SUBJECT: AMENDMENT NOS. 89 AND 82 TO FACILITY OPERATING LICENSE NOS. DPR-42
AND DPR-60: (TAC NOS. 71536 AND 71537)

UNITED STATES
NUCLEAR REGULATORY COMMISSION
WASHINGTON, D. C. 20555

ATTACHMENT TO LICENSE AMENDMENTS NOS. 89 AND 82

SAFETY EVALUATION BY THE OFFICE OF NUCLEAR REACTOR REGULATION
RELATED TO AMENDMENT NOS. 789 AND 82 TO
FACILITY OPERATING LICENSE NOS. DPR-42 AND DPR-60
NORTHERN STATES POWER COMPANY
PRAIRIE ISLAND NUCLEAR GENERATING PLANT, UNIT NOS. 1 AND 2
DOCKET NOS. 50-282 AND 50-306

UNIT 1 and UNIT 2
REACTOR COOLANT SYSTEM HEAT UP LIMITATIONS
(Applicable for First 20 EFY of Operation)

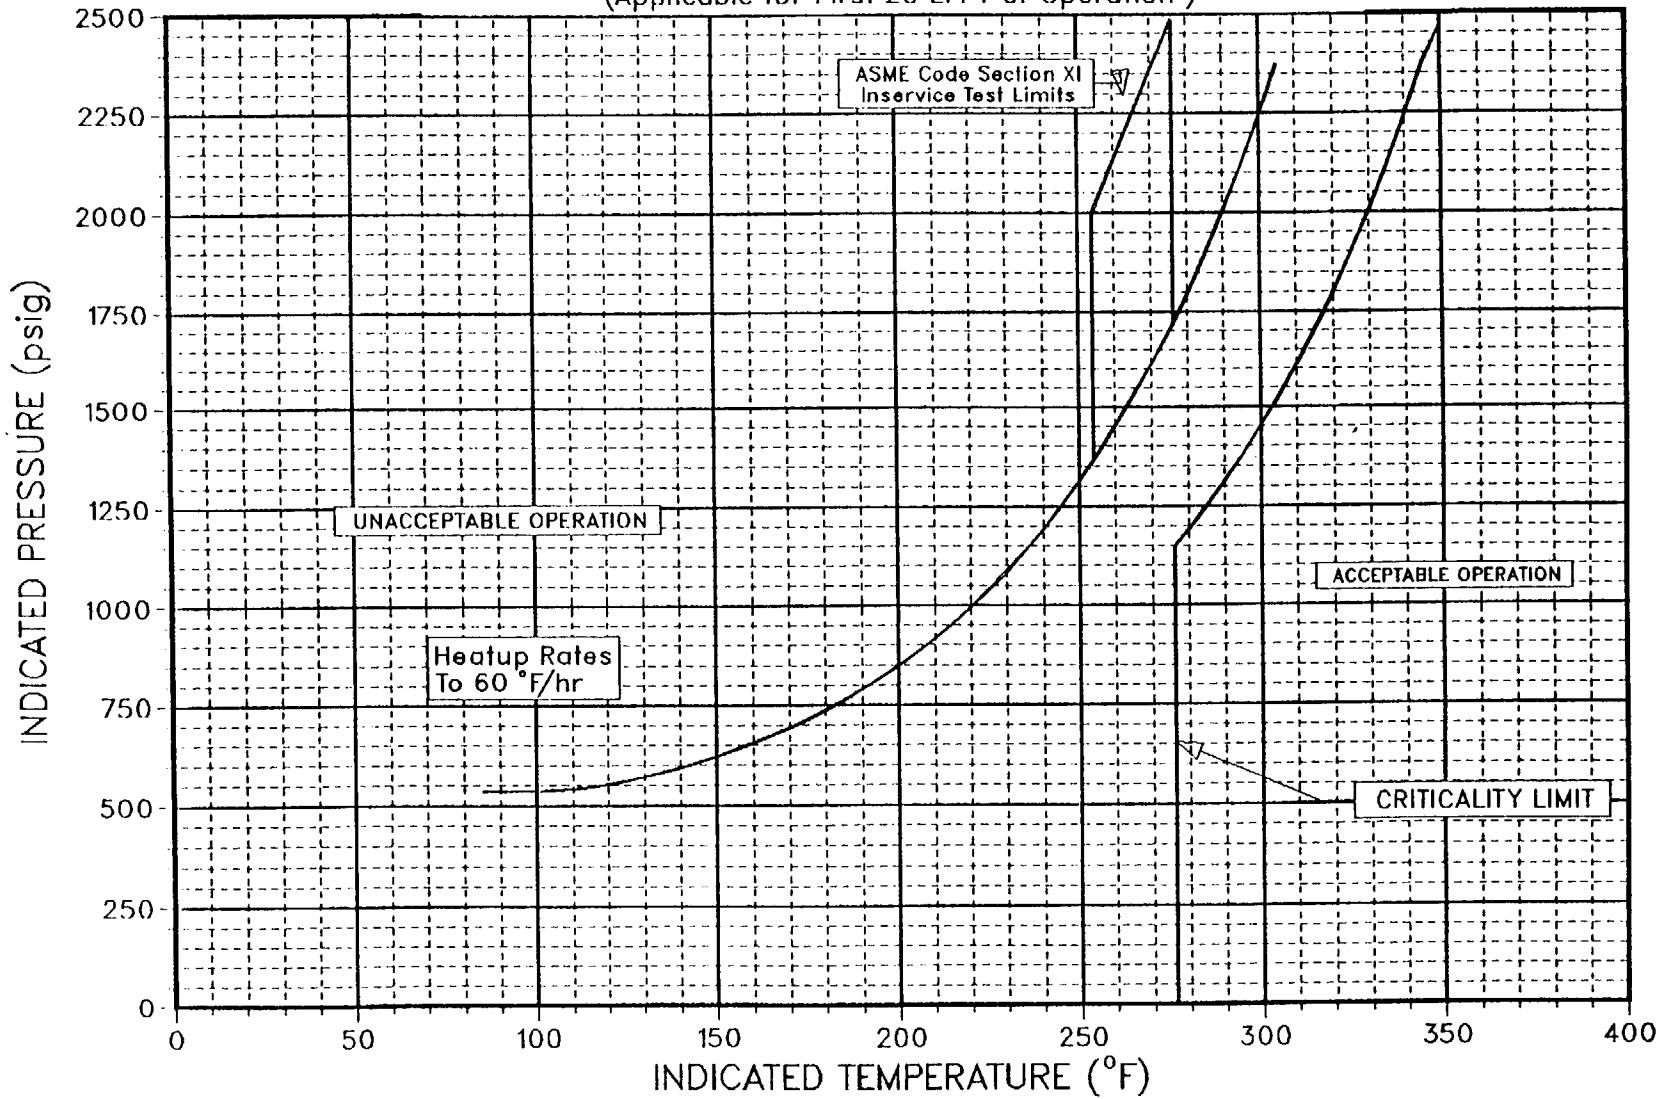
1. The effective limitation of existing reactor coolant system heatup and cooldown curves are revised from 15 to 20 effective full power years.
2. The word "vessel" appearing in TS.3.1.B3 is replaced with the phrase "steam generator shell."

The amendment revised the Technical Specifications by modifying the pressure-temperature limits taking into consideration the irradiation effects of the embrittlement of the reactor vessel material up to 20 effective full power years. Other modifications are administrative in nature serving to clarify the existing requirements.

Based on the above evaluation, the staff concludes that the proposed P/T limits on the reactor coolant system for heatup, cooldown, leak test, and criticality are valid through 20 EFPY, because the limits conform to requirements of Appendices G and H to 10 CFR Part 50. The licensee's submittal also satisfies Generic Letter 88-11, because the licensee used the method in RG 1.99, Rev. 2, to calculate the ART. Hence, the proposed P/T limits that would be incorporated into the PINGP-1 and PINGP-2 Technical Specifications are acceptable.
